Urgent Field Safety Notice SureTek™ Burr Hole Cover Kit, part of the Vercise™ Deep Brain Stimulation System, Retaining Clip Locking Difficulties – IFU Update

Appendix 1 – Vercise™ Deep Brain Stimulation Systems Surgical Implant Manual Updates

Table 1: Updates to Instructions for Use

Figure 23. Lock the Slider

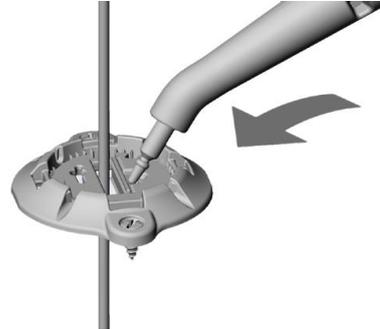
Surgical Implant Manual Section	Planned Updates
Securing the DBS Lead	<p>6. While stabilizing the DBS Lead, carefully position the Retaining Clip over the Base so that the DBS Lead is located in the open channel of the Retaining Clip. Position the Retaining Clip so that the static side of the opening is against the Lead (Figure 21).</p> <div style="text-align: center;">  </div> <p style="text-align: center;">Figure 21. Position the Retaining Clip Over the Base</p> <p>7. Push the Retaining Clip down into the Base. Ensure that the Retaining Clip is completely seated in the Base (Figure 22).</p> <div style="text-align: center;">  </div> <p style="text-align: center;">Figure 22. Push the Retaining Clip Into the Base</p> <p>8. Place the tip end of the Placement/Removal Tool into the closure dimple or anywhere along the length of the Slider on the Retaining Clip to push the Slider towards the DBS Lead until it locks into place. Use the tip end of the Placement/Removal Tool to apply pressure on the Slider face in the opposite direction to ensure that the Slider is fully locked (Figure 23).</p>

Note: If you have difficulty locking the Slider, you may need to remove the Lead Stylet before locking the Slider in place, or replace the Retaining Clip using another Burr Hole Cover Kit or Burr Hole Cover Spares Kit.
